Access Compliance Report

Public Rights-of-Way

Intersection ID: 20439	Main Street: FAIRVIEW_RD	Cross Street: SHARON_RD	Location: NW
ADA ID: 79055C02B337	Ramp Type: Perp	Initial Pass/Fail: Fail	Overall Compliance: No
Severity Score: 10			
Codes/Mitigation Info/Possible Solution		Field Measurements/Component Compliance

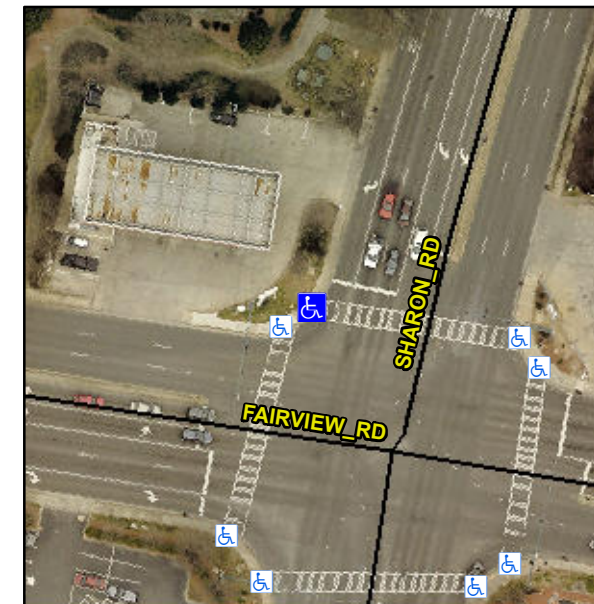
R304.5.1, R304.5.3

Compliance	Description	Data	Compliance	Description	Data
N/A	Ramp Length (in)	60.0	Yes	Ramp Slope (%)	6.5
No	Ramp Width (in)	41.5	No	Ramp XSlope (%)	3.4
N/A	Flare Type LT	N/A	N/A	Flare Type RT	N/A
N/A	Flare Slope LT (%)	N/A	N/A	Flare Slope RT (%)	N/A
N/A	Flare Traversable LT?	N/A	N/A	Flare Traversable RT?	N/A
N/A	Landing Length (in)	N/A	N/A	DWS Provided?	N/A
N/A	Landing Width (in)	N/A	N/A	DWS Contrast?	N/A
N/A	Landing Slope (%)	N/A	N/A	DWS Length (in)	N/A
N/A	Landing X Slope (%)	N/A	N/A	DWS Full Width?	N/A
N/A	Landing Curb? (Y/N)	N/A	N/A	DWS Offset (in)	N/A
N/A	Shared Landing?	N/A			
N/A	Gutter Ponding?	N/A	N/A	Gutter Slope (%)	N/A
N/A	Gutter Lip Ht (in)	N/A	N/A	Gutter X Slope (%)	N/A
N/A	Painted X Walk1?	Yes	N/A	Painted X Walk2?	N/A
	X Walk 1 Direction	To SE		X Walk 2 Direction	N/A
N/A	X Walk 1 Width (in)	112.0	N/A	X Walk 2 Width (in)	N/A
	X Walk 1 Slope (%)	1.4		X Walk 2 Slope (%)	N/A
	X Walk 1 X Slope (%)	1.0		X Walk 2 X Slope (%)	N/A

Remove & Replace Entire Ramp.
